F. Portages

P-4

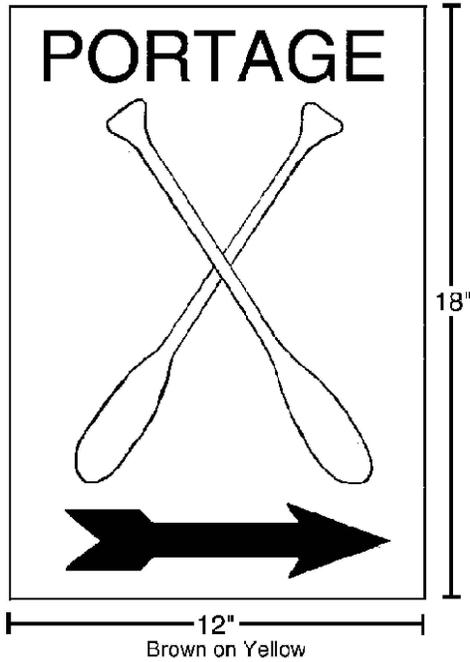
Good use of standard danger heading/color scheme. Placement and font are suitable for the wide river area.

None.

P-5

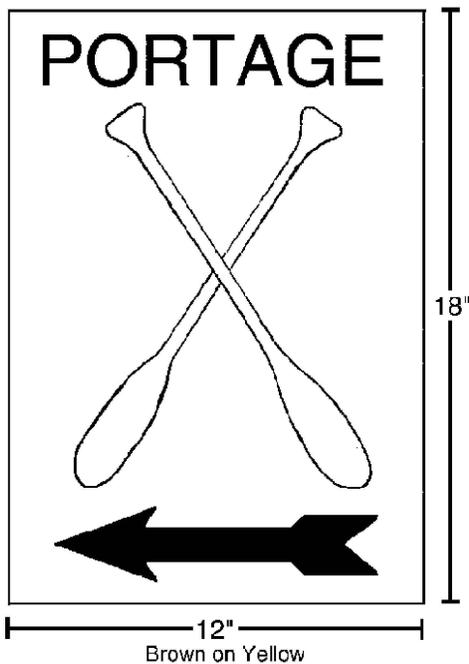
This portage graphic is included in the Hydro Users Group (HUG) recommendations on safety signage. Participating dam owners use this and the following two graphics to indicate portage trails/ areas. Standardization increases public recognition.

None.

P-6

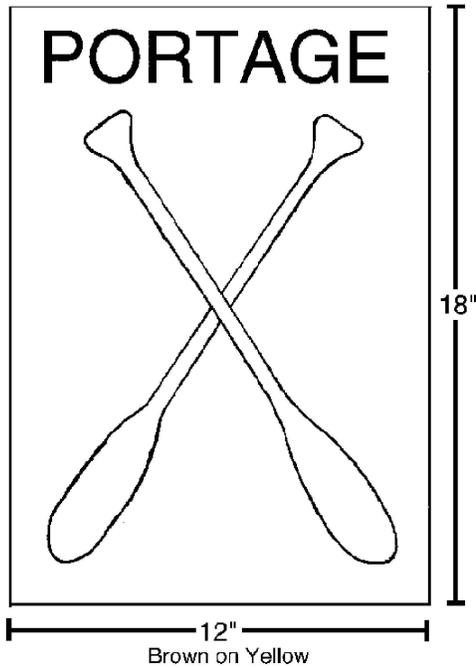
This portage graphic is included in the Hydro Users Group (HUG) recommendations on safety signage. Participating dam owners use this graphic to indicate portage areas. Standardization increases public recognition.

None.
